Access Compliance Report

Public Rights-of-Way

Intersection ID: 24479	Main Street: MEGINGTON_DR	Cross Street: SPRINGS_FARM_LN	Location: NE
ADA ID: 865758764780	Ramp Type: PerpDiag	Initial Pass/Fail: Fail	Overall Compliance: No
Severity Score: 8.75			
Codes/Mitigation Info/Possible Solution		Field Measurements/Component Compliance

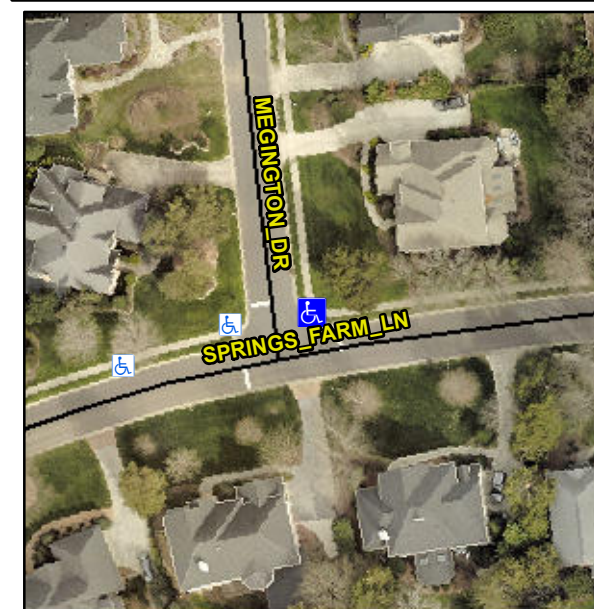
Compliance	Description	Data	Compliance	Description	Data
N/A	Ramp Length (in)	94.0	Yes	Ramp Slope (%)	7.0
No	Ramp Width (in)	47.0	Yes	Ramp XSlope (%)	1.7
N/A	Flare Type LT	N/A	N/A	Flare Type RT	N/A
N/A	Flare Slope LT (%)	N/A	N/A	Flare Slope RT (%)	N/A
N/A	Flare Traversable LT?	N/A	N/A	Flare Traversable RT?	N/A
N/A	Landing Length (in)	N/A	N/A	DWS Provided?	N/A
N/A	Landing Width (in)	N/A	N/A	DWS Contrast?	N/A
N/A	Landing Slope (%)	N/A	N/A	DWS Length (in)	N/A
N/A	Landing X Slope (%)	N/A	N/A	DWS Full Width?	N/A
N/A	Landing Curb? (Y/N)	N/A	N/A	DWS Offset (in)	N/A
N/A	Shared Landing?	N/A			
N/A	Gutter Ponding?	N/A	N/A	Gutter Slope (%)	N/A
N/A	Gutter Lip Ht (in)	N/A	N/A	Gutter X Slope (%)	N/A
N/A	Painted X Walk1?	No	N/A	Painted X Walk2?	No
	X Walk 1 Direction	To W		X Walk 2 Direction	To S
N/A	X Walk 1 Width (in)	N/A	N/A	X Walk 2 Width (in)	N/A
	X Walk 1 Slope (%)	0.4		X Walk 2 Slope (%)	2.5
	X Walk 1 X Slope (%)	1.5		X Walk 2 X Slope (%)	1.8

N/A	Ramp inside XWalk1?	N/A	N/A	Ramp inside XWalk2?	N/A
	Road Slope (%)	1.2	N/A	Clear Space?	N/A
	Road X Slope (%)	0.0	N/A	Clear Space to XWalk (in)	N/A
N/A	Any Obstructions?	N/A	N/A	Storm Grate/Utility Hazard?	N/A
	Obstruction Type			Storm Grate/Utility Type	
		N/A			N/A
		Yes		Surface Condition? (G/P)	Good

Remove & Replace Curb Ramp With Two New Directional Ramps or Equivalent.

R304.5.1
